Briggs Chaney Estates: Administrative Subdivision Plan No. 620180060

Plan No. 620180060: Request to create one lot for one one-family detached unit; located at 1105 Briggs Chaney Road; 4.71 acres; RE-2C and Upper Paint Branch Overlay zones; 1997 Cloverly Master Plan.

Recommendation – Approval with conditions

Figure 3 - Administrative Subdivision Plan

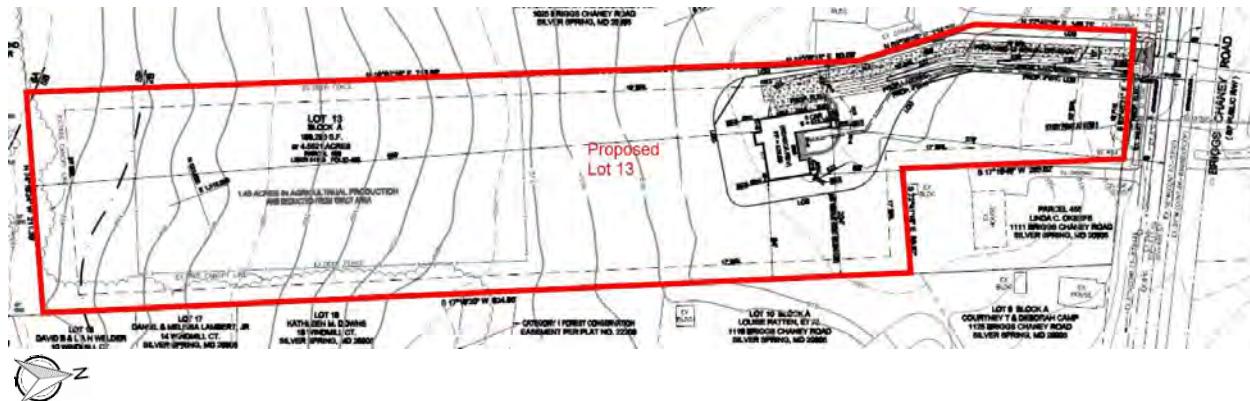
4. Prior to certification of the Administrative Subdivision Plan, the Applicant must revise the plans to include a 5-foot wide sidewalk with a 17-foot buffer on Briggs Chaney Road along the frontage of the Subject Property unless the requirement is waived by MCDPS.

Attachment D - Forest Conservation Plan

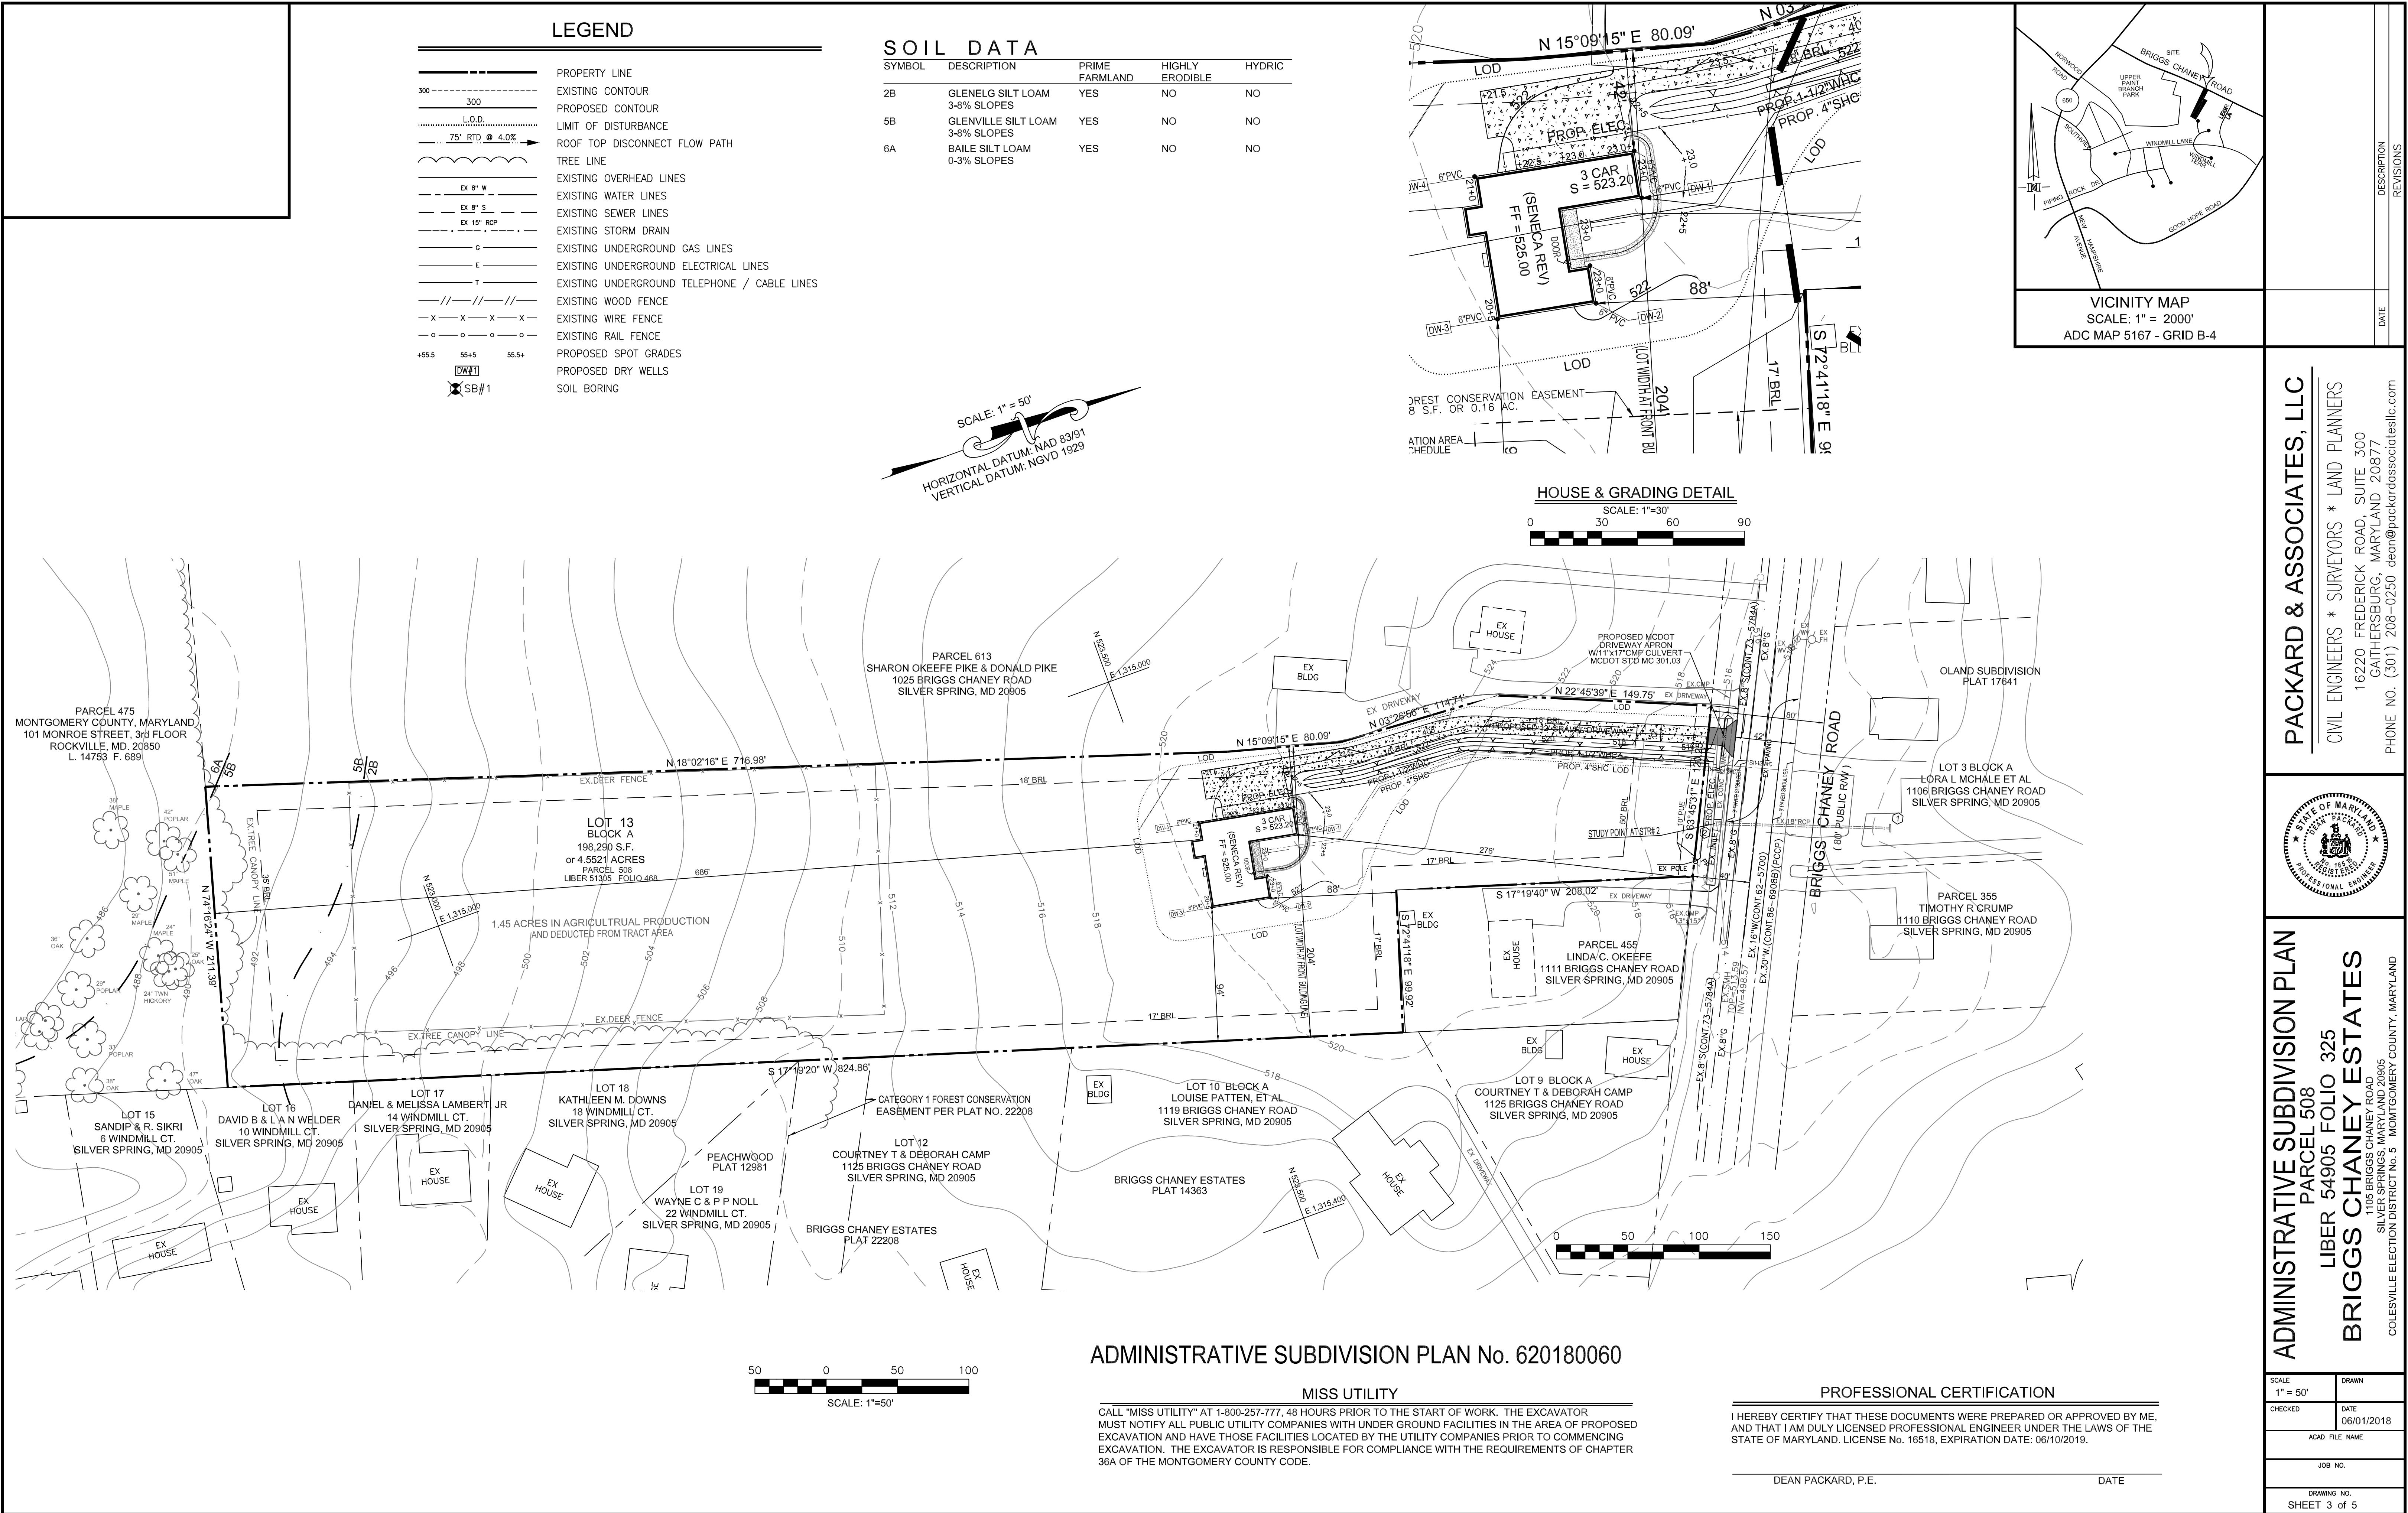
- a. Prior to Certification of the Administrative Subdivision Plan, the Applicant must revise the FCP to:
 - i. Demonstrate how the afforestation requirement will be met. If any portion of the afforestation requirement will be met off-site, prior to the start of any demolition, clearing, grading or construction on the Subject Property, the Applicant must record an M-NCPCC approved Certificate of Compliance to use an M-NCPCC approved off-site forest bank to satisfy the portion of the afforestation requirement that is not being met on the Property.

- ii. Correct the deed reference on the drawing.
 - iii. For the planting that will occur onsite, the afforestation plant stock sizes must be revised to a minimum of 1-inch caliper trees and shrubs with a height of 18-24". The quantities of trees must be adjusted accordingly per Chapter 22A.00.01.08(E)(3)(c) of the Forest Conservation Regulations.

- iv. Revise the limits of disturbance to include the water and sewer house connections, and any proposed off-site disturbance.
 - b. The Limits of Disturbance ("LOD") shown on the Final Sediment and Erosion Control Plan must be consistent with the LOD shown on the approved FCP.

Attachment G – WQP Impervious Surface Plan

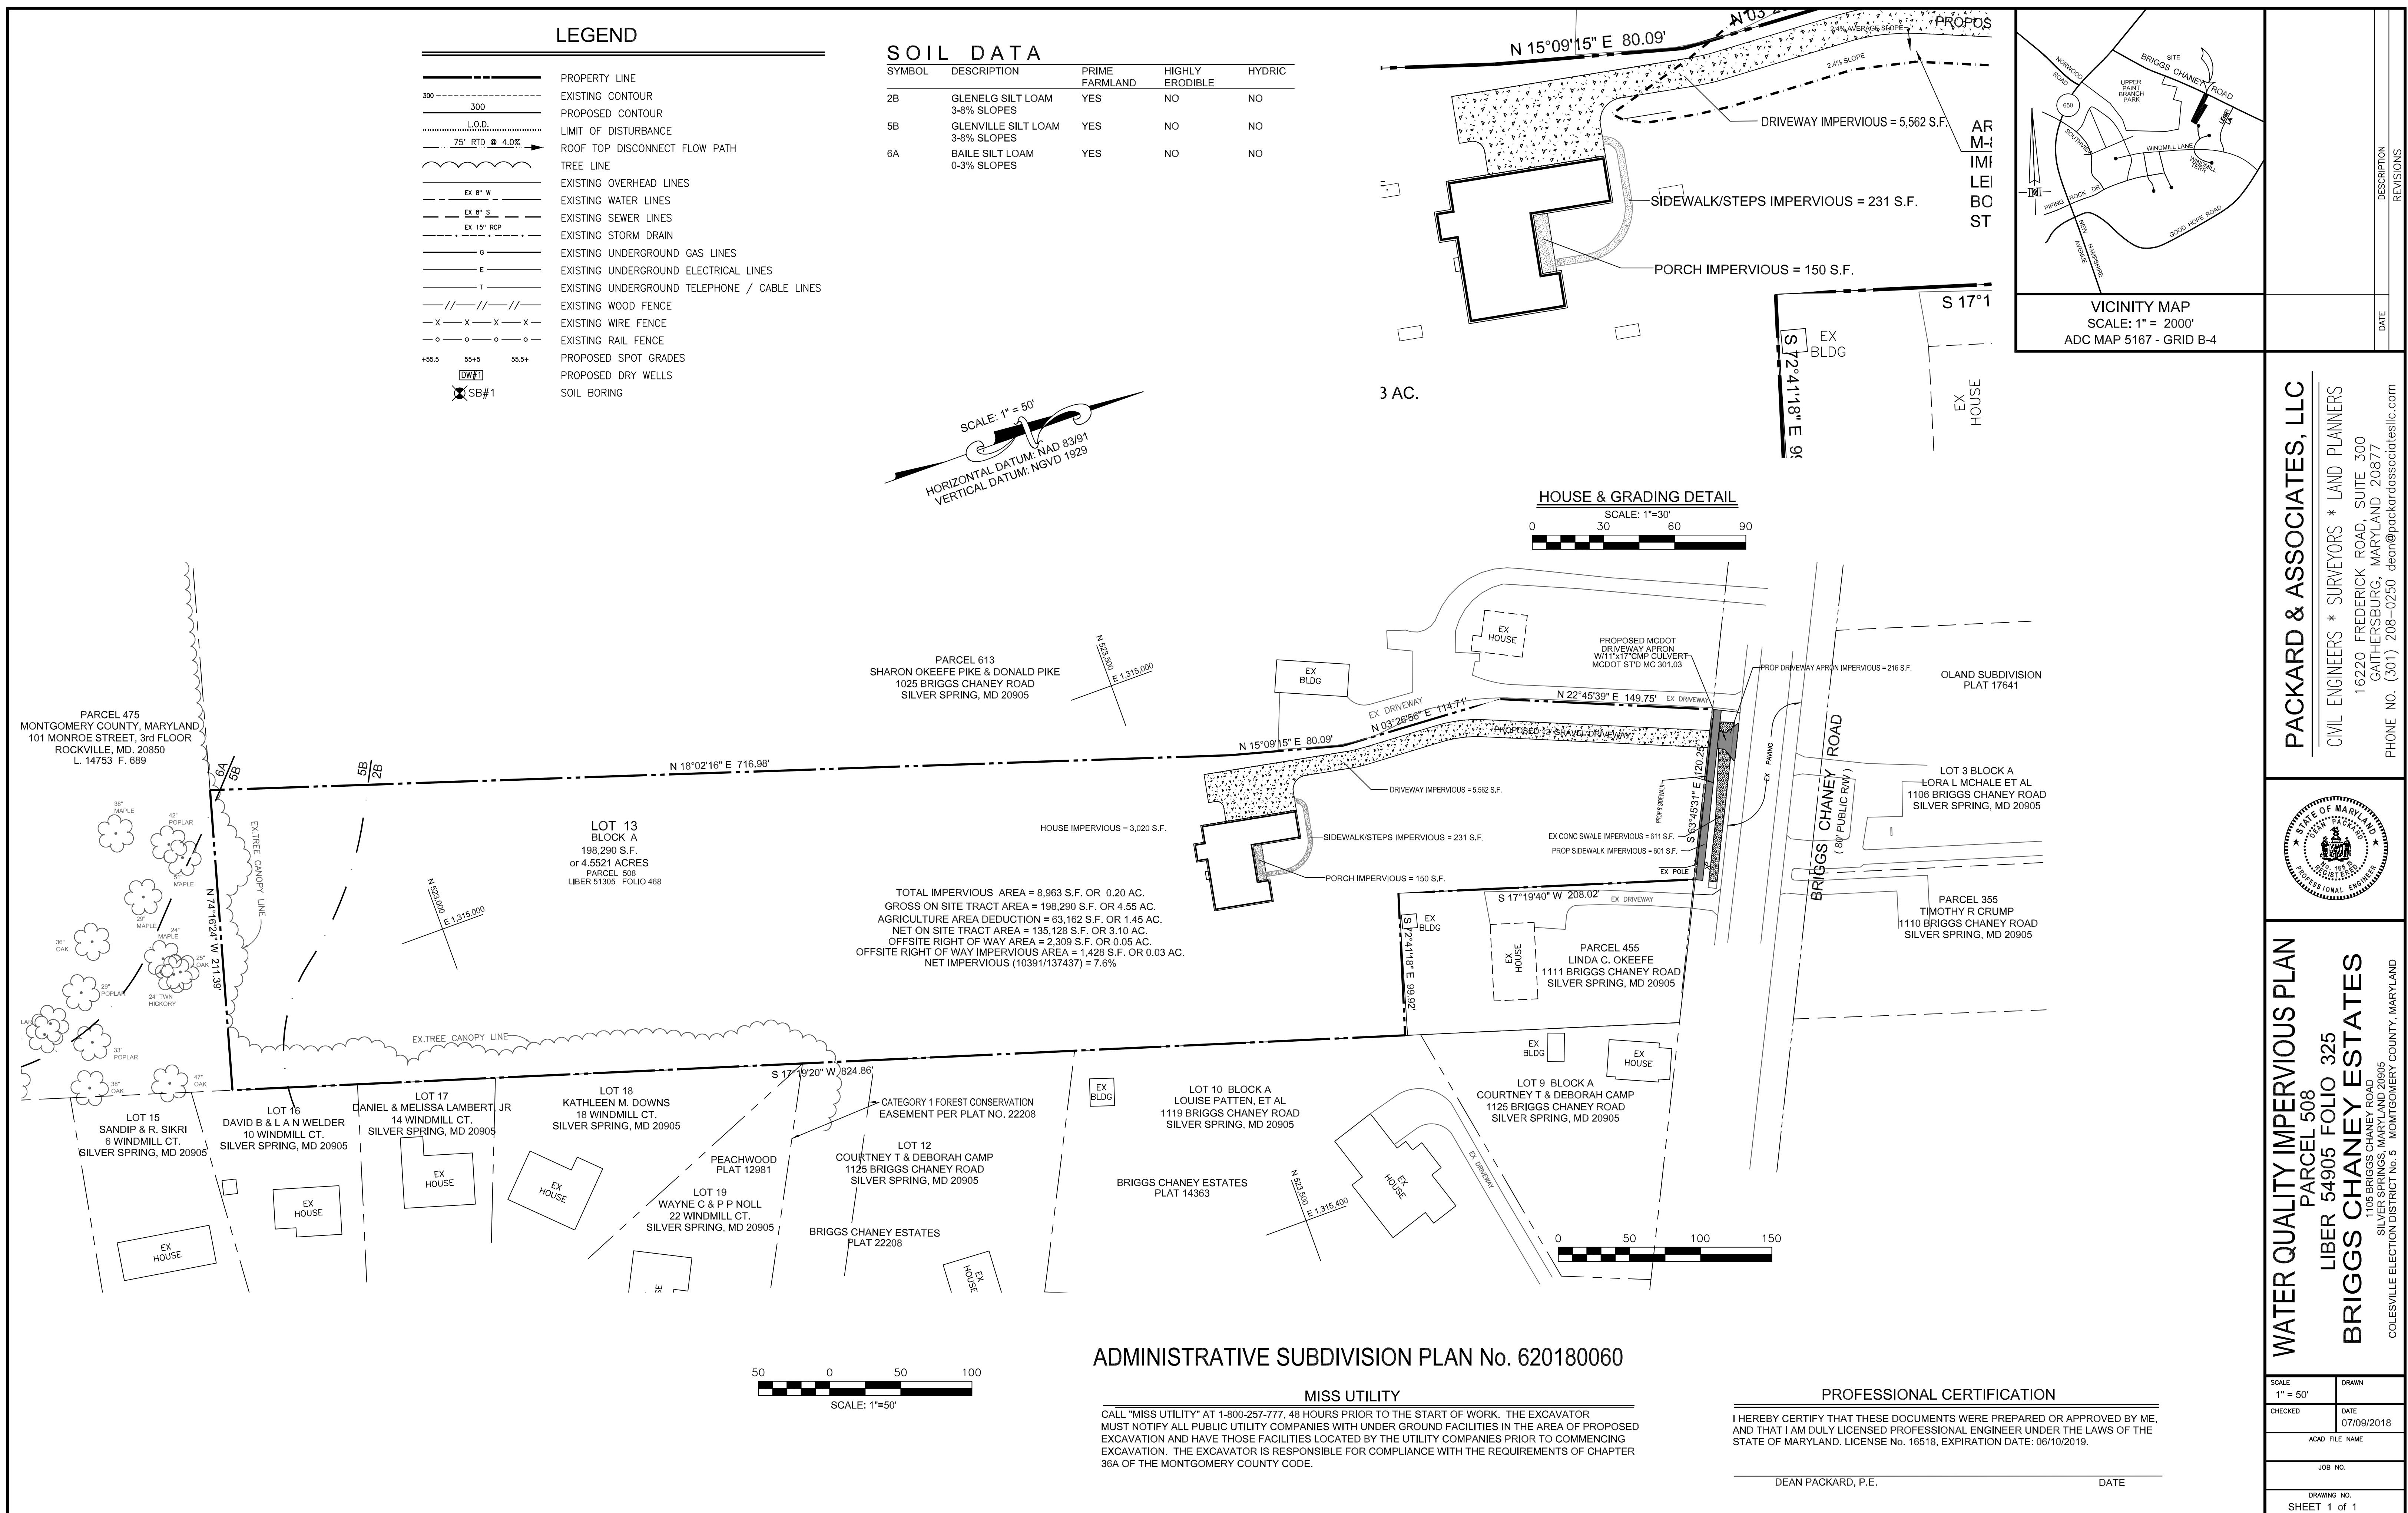
- a. Prior to certification of the Administrative Subdivision Plan, the Applicant must submit a revised Impervious Surface Plan to include all on-site and off-site impervious surfaces, both existing to remain and proposed as part of this Application, using the methodology illustrated in the *Environmental Guidelines*. The Impervious Surface Plan must demonstrate compliance with the 8.0 percent impervious surface limit.
